Title: **QUALITY AUDIT**  
**For;**  
**Proposed Moygaddy Castle SHD**

Client: **OCSC .**

Date: **August 2022**

Report reference: **1577R01**

#### 3.1 Issue

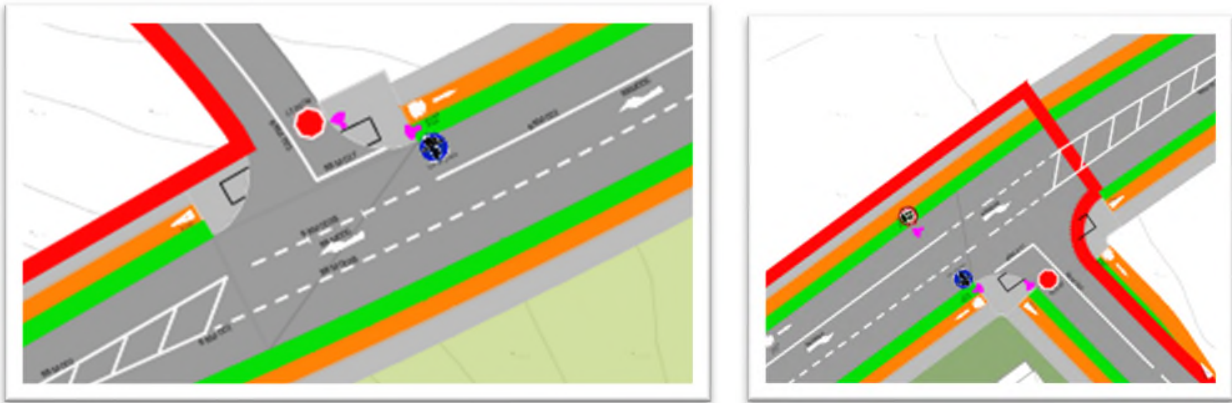
Both junctions on the MOOR extension are simple priority junctions. There are no facilities for pedestrians or cyclists to cross from one side to the other.

It is recommended that crossing facilities be provided for vulnerable road users.

3.1	Yes	Yes	Toucan Crossing to be added with Detailed design on the MOOR north of the junction with the L6219 (Eastern)	Yes
3.2	Yes	No	The red line has been adjusted to take account of verge requirements for forward visibility. Pedestrian and cyclist infrastructure will be provided along this road as part of the future development of this part of the masterplan lands.	Yes

### 3.2 Issue

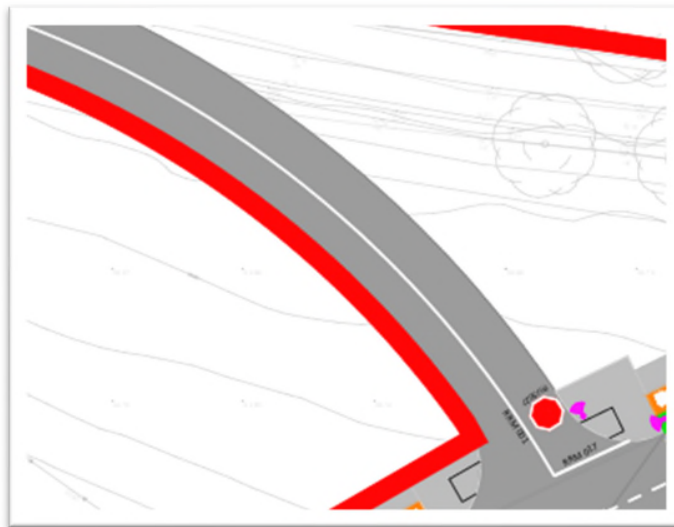
The tie-in with the existing L2214-3 and the realigned L2214-3 is shown to be constructed tight to the land boundary. This may leave no room for refuge in a verge or footpath for pedestrians. This could lead to collisions with vehicular traffic,

It is recommended that that a suitable verge width be provided.

It is also recommended that the footpaths be returned around the sideroad of the junction of the western tie-in as far as a suitable transition point for transfer to on-road pedestrians.

### 3.4 Issue

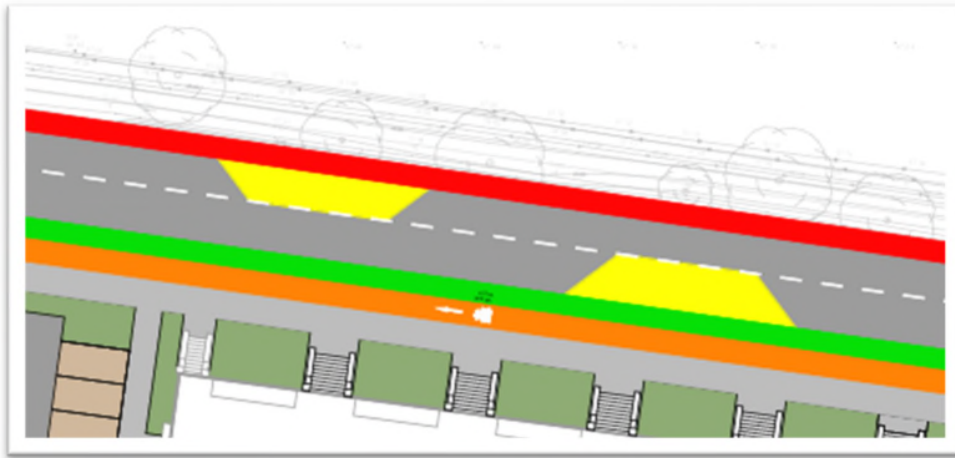
It is proposed to provide two chicanes on the L4413 as a means of providing traffic calming. It is anticipated that this will be a relatively heavily trafficked link/arterial road and this type of traffic calming may not be appropriate as approach speeds may be too high and this could lead to head on collisions.

It is recommended that more appropriate traffic calming measures be provided to suit the nature of the road.

3.4	No	No	The chicanes will not be installed until the MOOR is complete, and the purpose is to deter through vehicles from using the L6219 in favour of the MOOR.	Yes

### 3.8 Issue

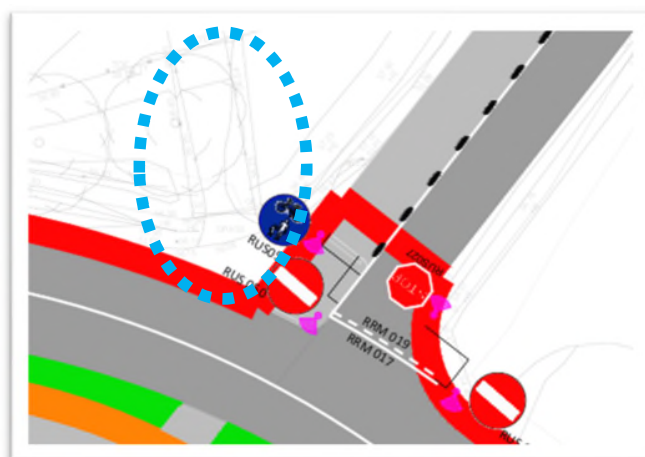
There is an agricultural access at the L2214 junction which has limited visibility. It is unclear if vehicles will be able to enter/exit this access safely given the proposed works.

Ensure the access is accommodated for and that suitable visibility is provided.

3.7	Yes	Yes	OCSC have checked the visibility and are satisfied that subject to low planting only in the landscaped area visibility is maintained appropriately.	Yes
3.8	Yes	No	Field is within the developer owned land. The developer has confirmed that his access is not in-use and will be closed as part of this development. Access will be given through the adjacent field to the west.	Yes
